# (CBM Caledon Quarry)

## CAART COMMENT SUMMARY TABLE RESPONSE #1 – [BLASTING]

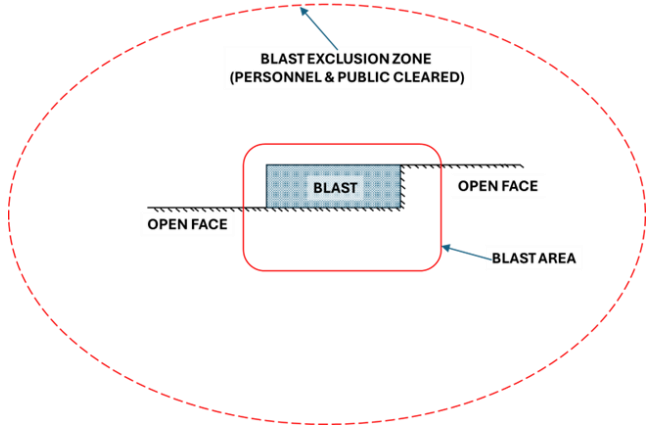
5.	The drawing shows the best estimate of the area where the depth of rock excavation would exceed 25 meters. This should be clarified in the report text. RESPEC recommends splitting the bench into two benches of approximately equal height as the pit wall approaches 25 meters in height to allow recovery of all resources. Having a bench of 25 meters and a secondary bench of 3 meters where the final wall height is 28 meters would not be economical or practical. This proposed split would also reduce	Blast Impact Assessment: Page 9, Figure 5	As the quarry wall approaches 25 meters (m), the bench will be split into two benches of approximately equal height to allow recovery of all resources. This would result in a maximum bench height of approximately 25 m as shown in Table 2. The vibration monitoring records will inform when bench height should be split in order maintain compliance with the regulatory limits.	Resolved

Initial CAART Comments (Date)	Page / Section	Applicant Response (January 15, 2025)	CAART Response (Date)
	the explosive loading per delay for each blast, lowering potential vibration levels (see bullet on page 5 [Page 24, Table 2]).
